## REVISION TRANSMITTAL

This sheet transmits Revision 1 to CAB-34-03, which:

NAVIGATION - GARMIN G1000 SYSTEM SOFTWARE UPGRADE TO VERSION 0767.25

CAB-34-03  
Page 1 of 14

Figure 1. Garmin G1000 System Software Upgrade to Version 0767.25 (Sheet 1)

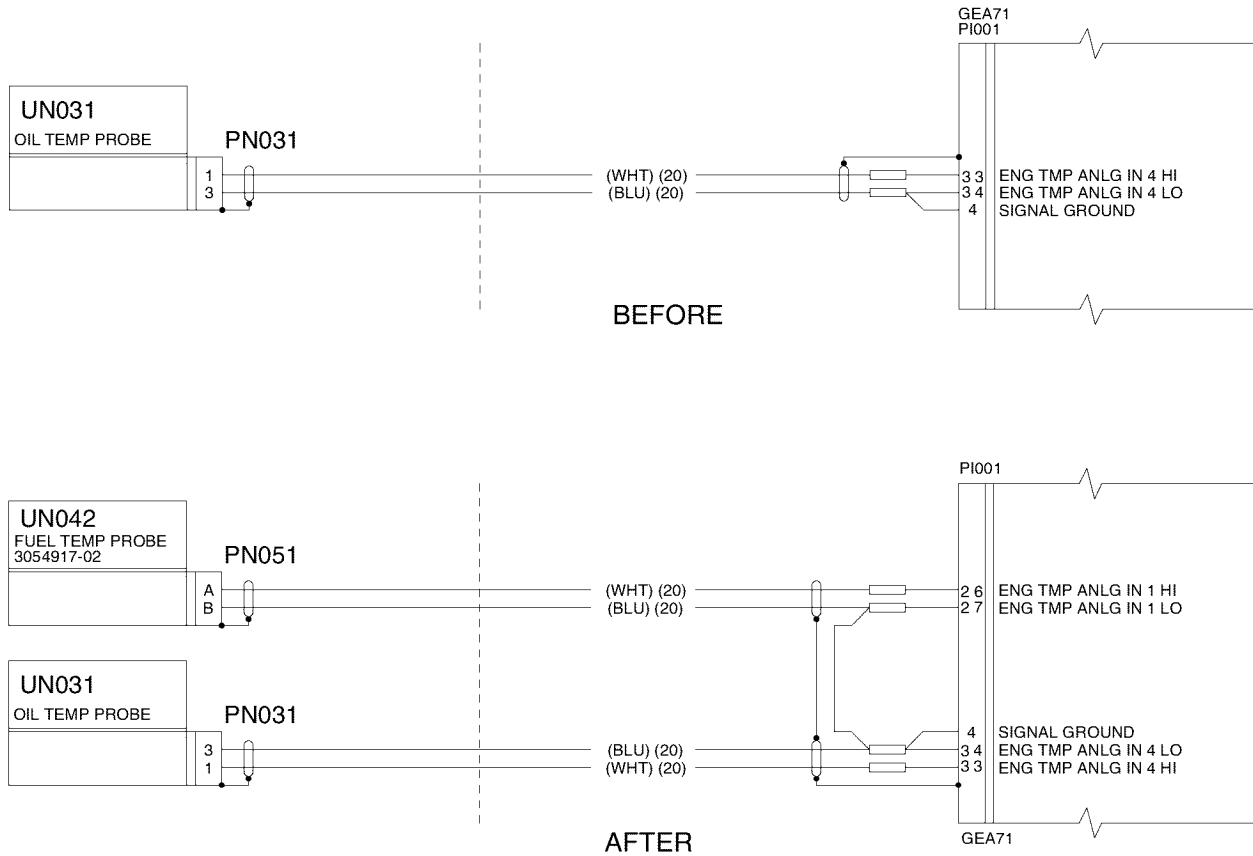
- C. (Refer to Figure 1, Sheet 1 and 2.) Add wiring from GEA71 to Fuel Temp Probe as follows:
    - (1) Remove pilot seat. (Refer to Cessna Model 208 Maintenance Manual, Chapter 25, Flight Compartment - Maintenance Practices.)

- (2) Remove PFD1, MFD, and GEA71.
    - (3) (Refer to Figure 1, Sheet 1.) Remove GEA rack backplate from rack, remove GEA mating connectors from the backplate and do the wiring modification on Connector Reference Designator PI001 (Garmin Reference Designator 1P701).

**NOTE:** ALL WIRES ARE 22 GAUGE UNLESS MARKED OTHERWISE.

Figure 1. Garmin G1000 System Software Upgrade to Version 0767.25 (Sheet 2)

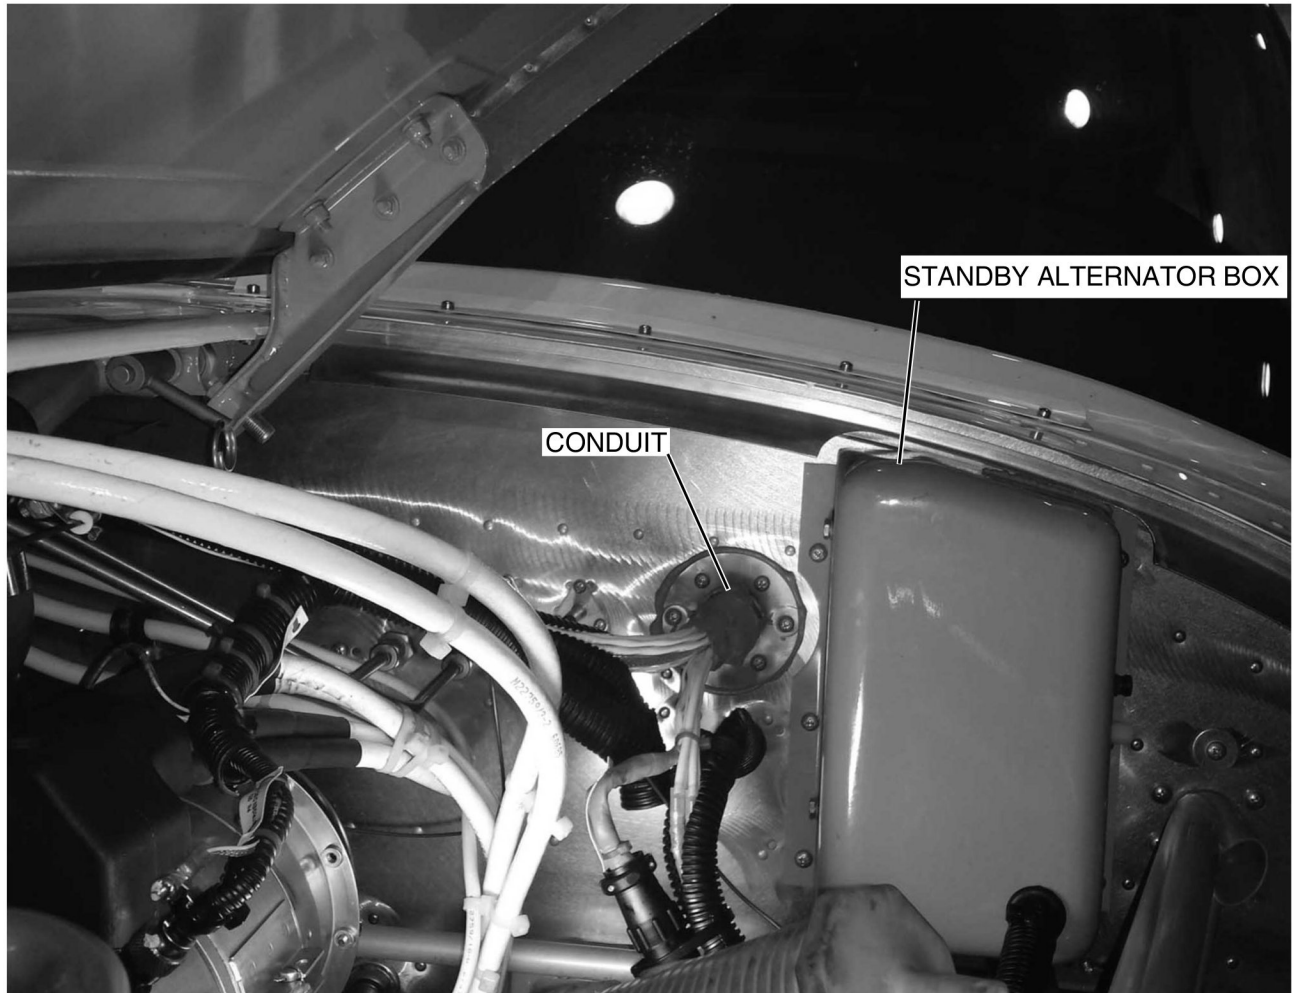
- (4) Route a wire to the left side of the bulkhead.
    - (5) Remove left hand engine side cowling.
    - (6) (Refer to Figure 1, Sheet 2.) Remove the firewall fuselage conduit, which is next to the standby alternator box.

- (7) Remove tie straps and sealer from inside of the conduit feed-through.
    - (8) Route wiring from left hand side of the bulkhead through the conduit to the left hand engine using the existing wire bundle. Remove cap from fuel temp probe.

- (9) Terminate the wires and connect to the fuel temp probe.
- (10) Refill U000117 sealant in the conduit and reinstall the conduit. Replace any tie straps on the conduit.  
**NOTE:** Allow sealant appropriate time to cure.
- (11) Reinstall PFD1, MFD and GEA71.
- (12) Reinstall pilot seat. (Refer to Cessna Model 208 Maintenance Manual, Chapter 25, Flight Compartment - Maintenance Practices.)
